Oakland Chinatown Coalition  
Oakland Chinatown Chamber of Commerce  
Asian Health Services

October 24, 2003

RE: Jack London Square Redevelopment Project  
SCH #2003022086

Figure A

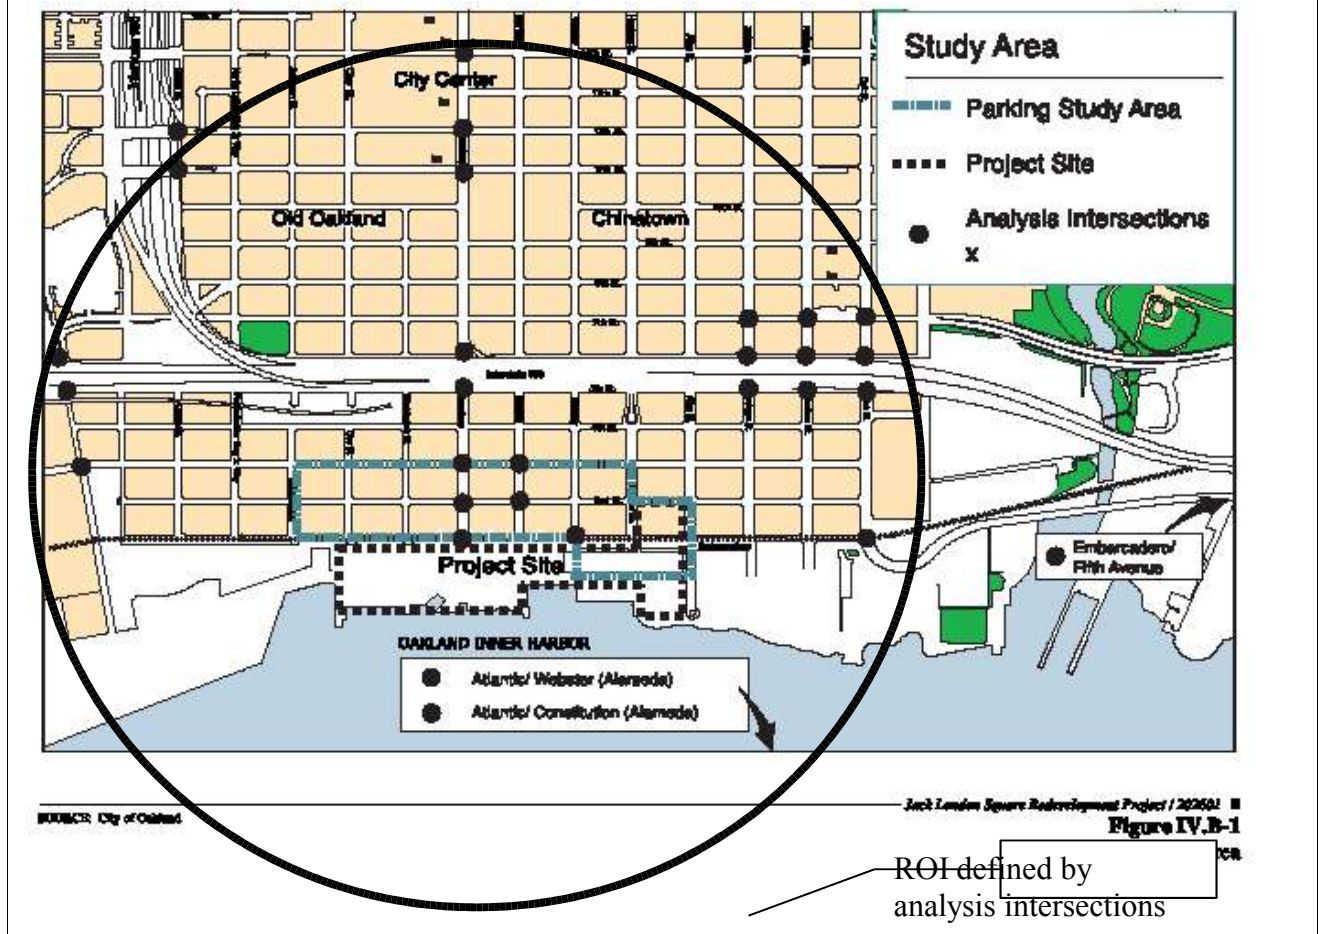
1. The intersections that the DEIR screened into the study can be used to define “proximity to the project site” Chinatown clearly falls within a circle comprised of the analyzed intersections. See Figure A.
2. Webster Street intersections must be included among those important to the area’s traffic circulation,. It is only southbound arterial, between Broadway and Oak connecting Grand Avenue to the Embarcadero. The DEIR itself acknowledges the importance of Webster as the connecting link between Chinatown and the Jack London District.<sup>9</sup> It also is the primary route for traffic traveling to the Jack London District from a large portion of the city north of Grand.
3. Chinatown intersections – especially along Webster, Harrison, and Franklin – belong in the study area because they will host Project traffic trying to escape unavoidable LOS F delays at intersections along Broadway.
